North Dakota CarbonSAFE: Project Tundra Oliver County, North Dakota

Pursuant to the Air Pollution Control Rules of the State of North Dakota, the Department of Environmental Quality (Department) has completed its final review of your permit application dated June 2, 2023, to obtain a Permit to Construct for initial construction and operation of the Dakota Carbon Center CO2 Separation and Purification Plant to be located in Oliver County, North Dakota.

After reviewing the draft permit to construct, EPA submits the following comments. As explained in more detail below, these technical comments are related to source aggregation, incorporation by reference, monitoring, recordkeeping, reporting requirements, modeling found in the permit and corresponding air quality effects analysis, and Clean Air Act (CAA) Section 112(g).

**Response to Comments Received
by
The North Dakota Department of Environmental Quality
on
Draft Air Pollution Permit to Construct No. ACP-18197 v1.0
DCC East Project LLC - Dakota Carbon Center CO2 Separation and Purification Plant
Oliver County, North Dakota**

Figure A-1. Site Layout

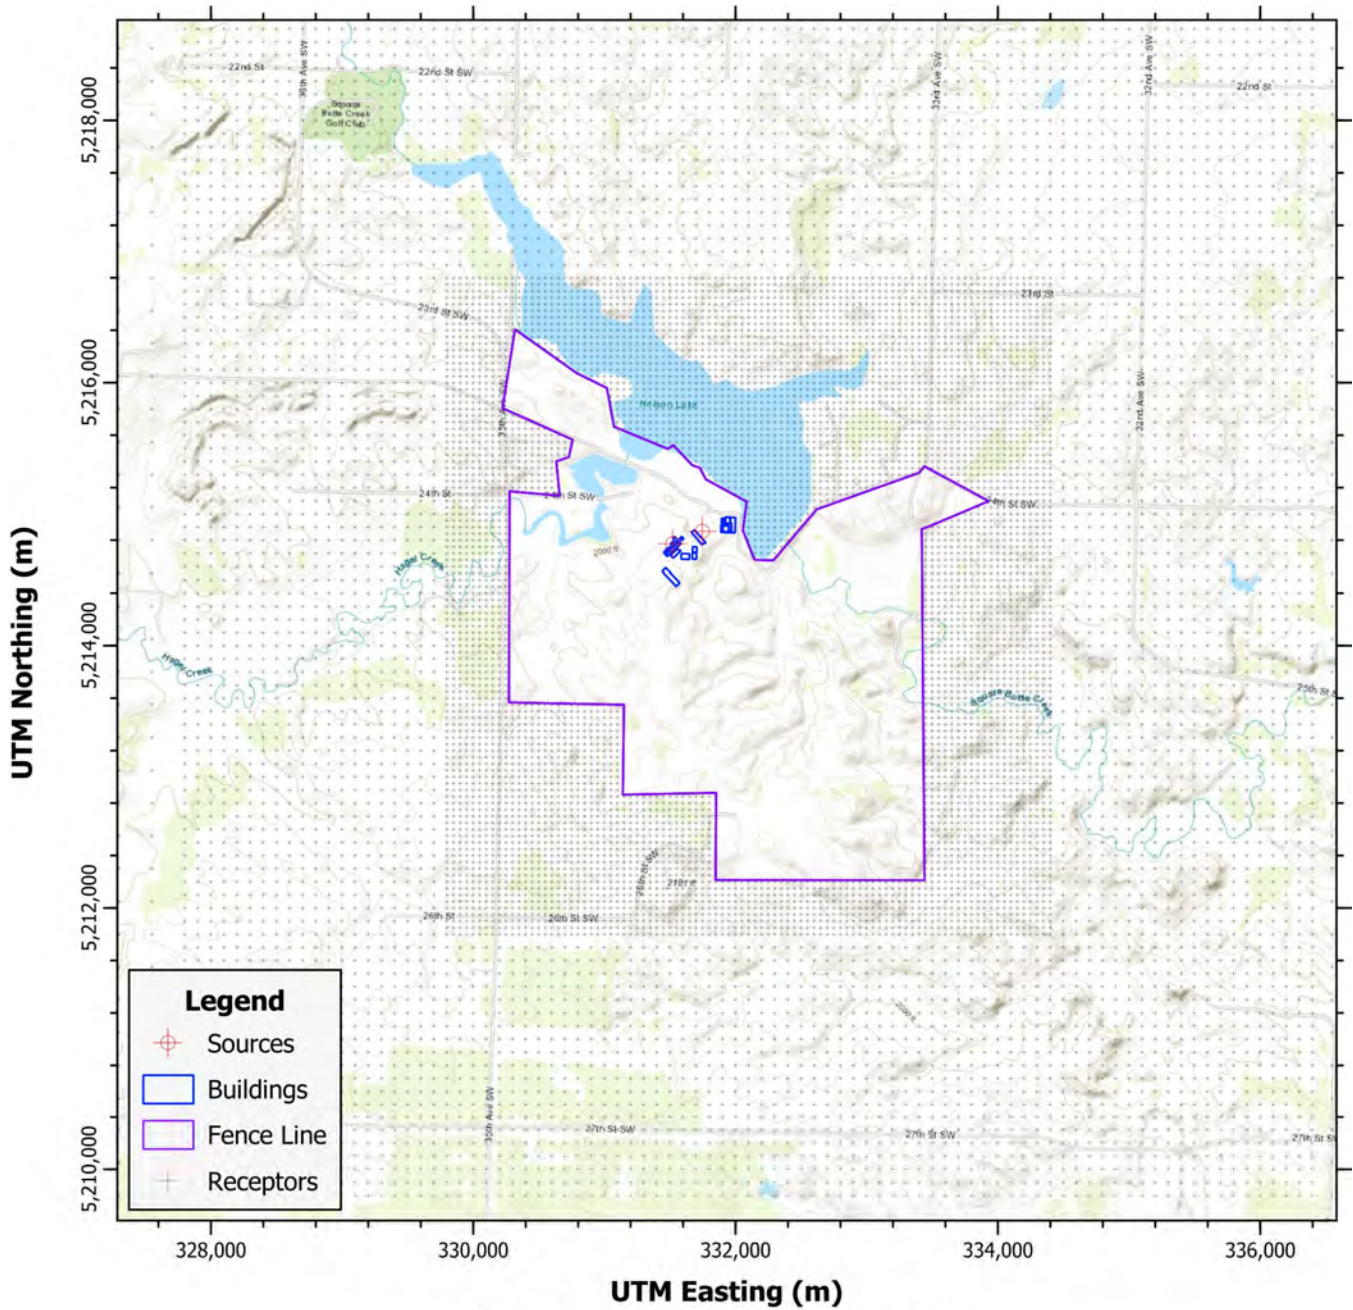
Figure A-1 in Appendix 2 of the AQIA establishes what appears to be an ambient air boundary for the facility that is used to delineate where the air dispersion modeling receptor grid is located. This receptor grid is shown in Figure A-4 and excludes the area inside the defined ambient air boundary.

However, in the permit’s June 2, 2023 application, in Figure 2-1, the larger ambient air boundary contains a smaller defined area labeled as the DCC Separation and Purification Plant and locates the MRY facility’s Unit 1 and Unit 2 in relationship to the DCC facility. The larger ambient air boundary area used in the air dispersion modeling process to establish the modeling receptor grid appears to be the MRY ambient air boundary and the DCC ambient air boundary, according to Figure 2-1 appears to be a smaller area located within the MRY boundary. As it contains MRY Unit 1 and Unit 2, this would appear to be the MRY ambient air boundary.

DCC Response: In its comments, EPA Region 8 recommended that NDDEQ review the cited documents and confirm that the ambient air boundary and associated receptor grid used in the air dispersion modeling for the DCC Facility for accuracy. If that boundary is different than the one used to define the model’s receptor grid, then EPA recommended that the NDDEQ or the applicant rerun the model to confirm that no NAAQS concerns exist.

Minnkota maintains a fenced physical barrier preventing unauthorized entry of the public into the MRY Station. DCC East used the fenced MRY Station property boundary in its modeling demonstrations. The fenced barrier will remain after the start-up of the DCC Facility. The proposed operation plan for the DCC Facility consists of use of the existing MRY Station security gate for designated access across Minnkota property to the DCC Facility secured site. The DCC Facility will be located on leased property, adjacent to the MRY Station, and will be considered “nested” within the footprint of Minnkota’s access restrictions. The MRY Station is a critical infrastructure site and requires strict adherence to security protocols to mitigate access risk. As
